## GW-310, Williams Four Corners North Crandell Compressor Station

**16. OCD Inspections:** The OCD performed an inspected this facility on November 19, 2008. David Bays and Brandon Powell were in attendance. All photographs referenced below are located in the attachment of this permit. The inspection concluded the following:

**Figure 2 Site Plan**  
**North Crandell Compressor Station**  
Not to Scale

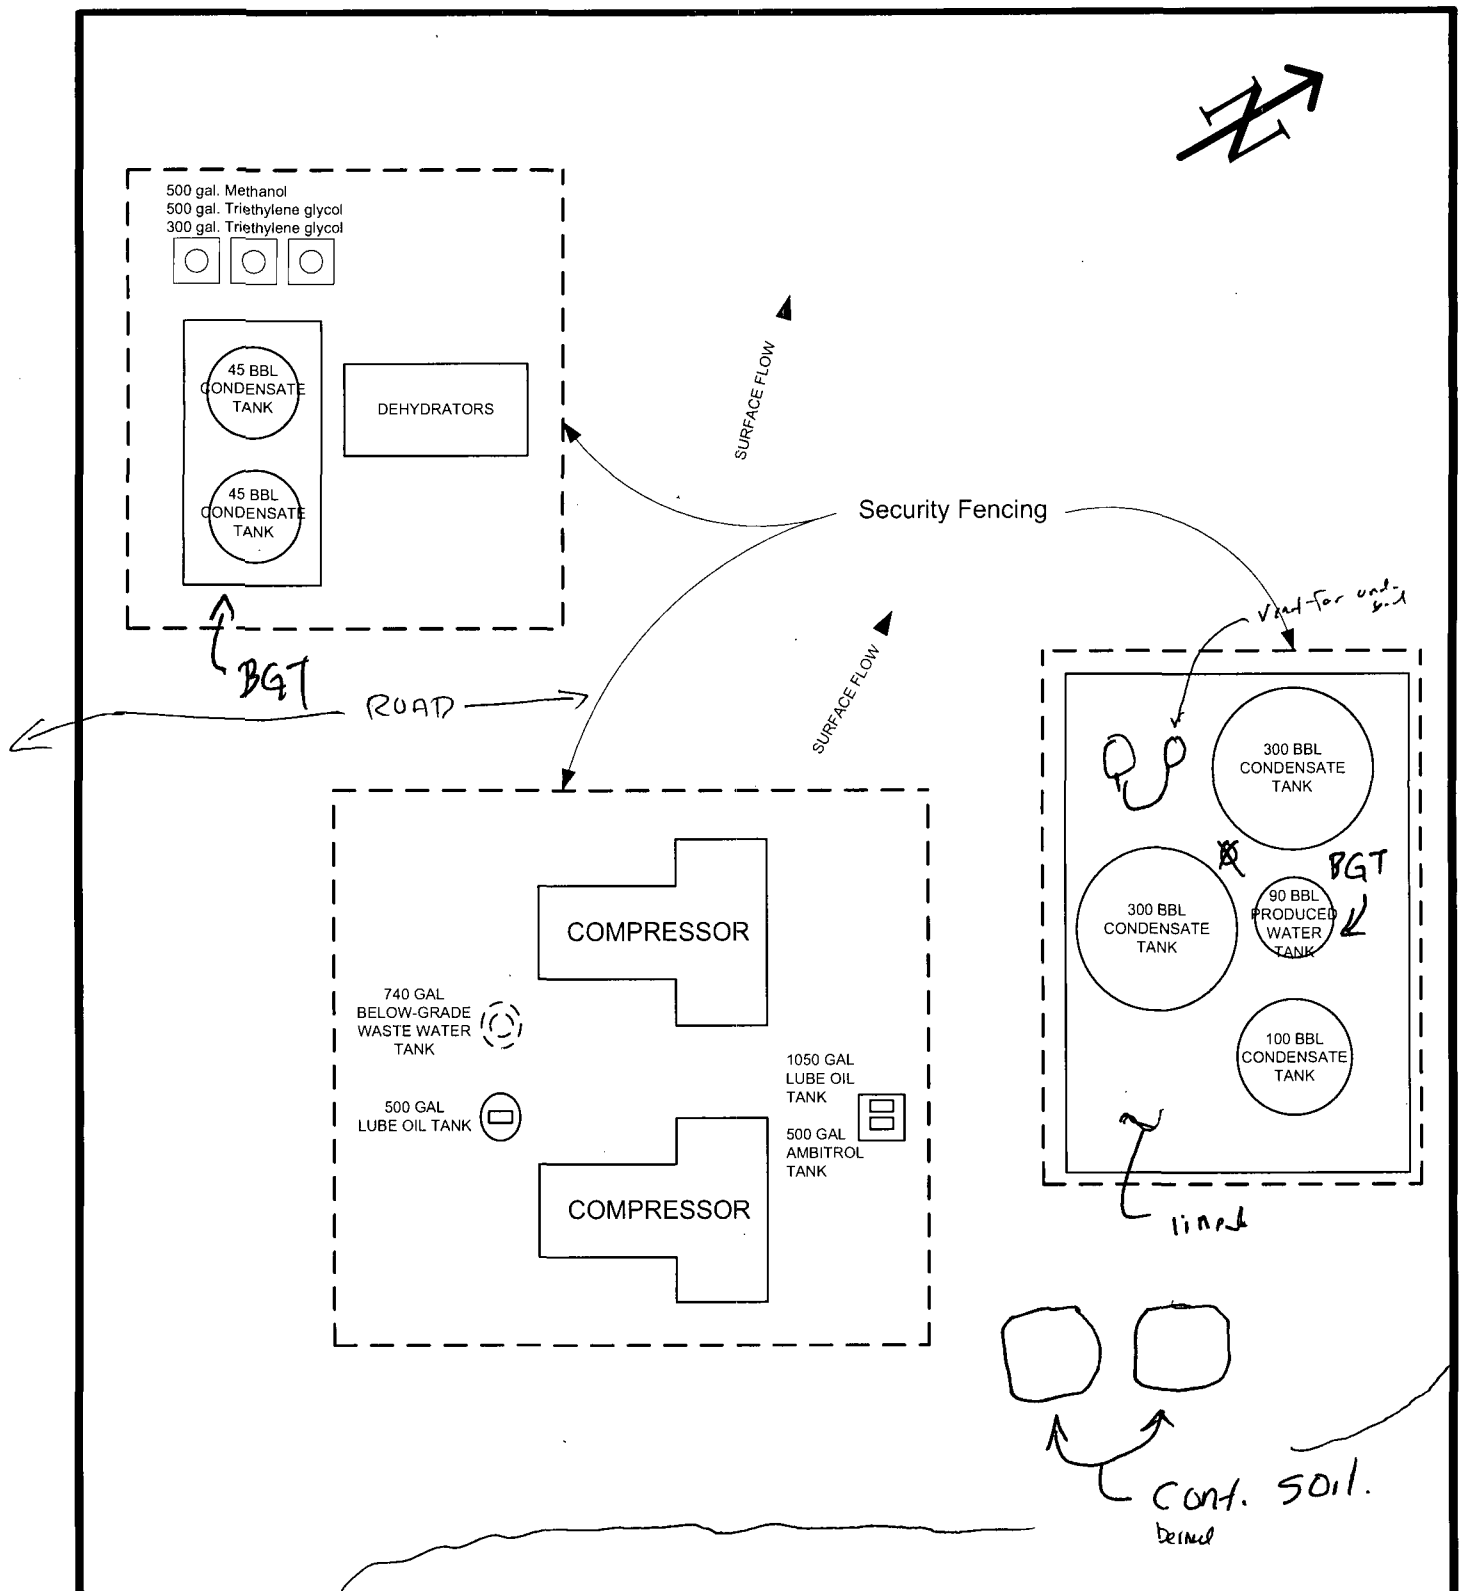
1. **Photo 1 & 2:** Two contaminated soil staging areas are located outside a fenced in area. Williams shall either place the staging area (land farms) within already existing fenced in area or put a fence are this staging area.
2. **Photo 3:** A below grade tank within the Dehydrator fenced in area is missing a cap for its leak detection system. Williams shall cover with appropriate cover and properly maintain inspection of the system.
3. **Photo 4:** A berm within the dehydrator area has been compromised. It appears that a vehicle has driven over the bermed area. Williams shall adequately reconfigure their berms to meet permit conditions.

Williams Four Corners shall submit a report with resolutions to the findings of this inspection stated above within **90 days** from this permit date, by **March 3, 2009**. The overall facility is in excellent condition. The OCD commends Williams Four Corners for the overall status of this facility.
